DeltaPSU Product Notice

Medical MDS-250, MDS-300 and MDS-400 Series Product Change Notice

1. CN101 Connector Change

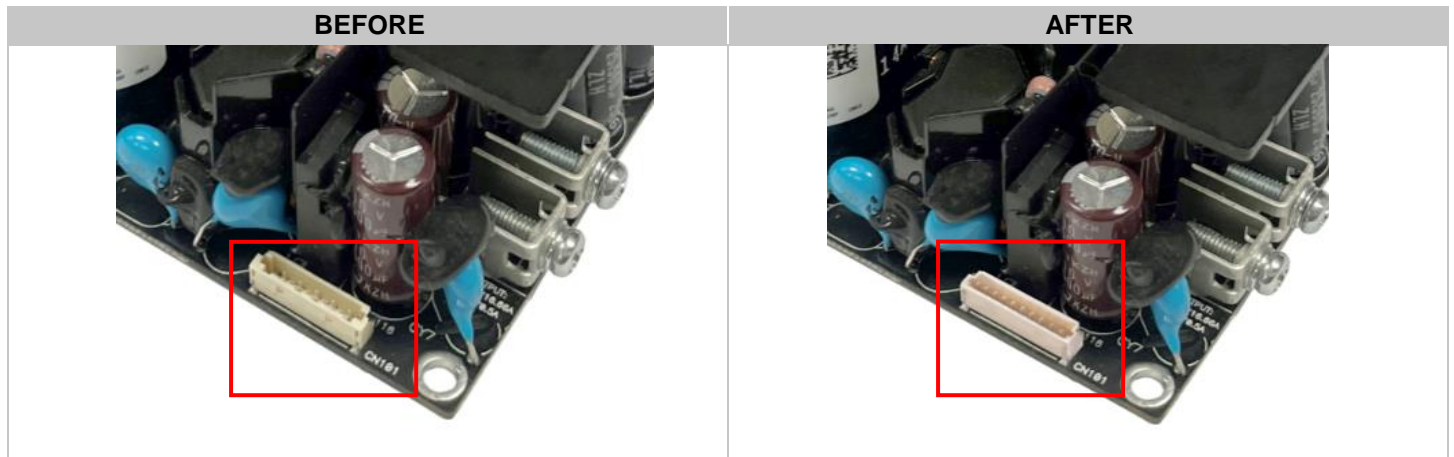
Control connector (CN 101) from Molex used in MDS-250, MDS-300 and MDS-400 medical power supply series will be obsolete (EOL). Delta will hence change connector manufacturer from Molex to JST.

BEFORE	AFTER
<p>PCB Side Molex 104141-1010 Rating : DC50V/1A</p> <p>System Side Housing : Molex 1041421000 Terminal : Molex 1045398002</p>	<p>PCB Side JST BM10B-SRSS-TB1(LF)(SN) Rating : DC50V/1A</p> <p>System Side Housing : JST SHR-10V-S-B & SHR-10V-S Terminal : JST SSH-003T-P0.2-H</p>
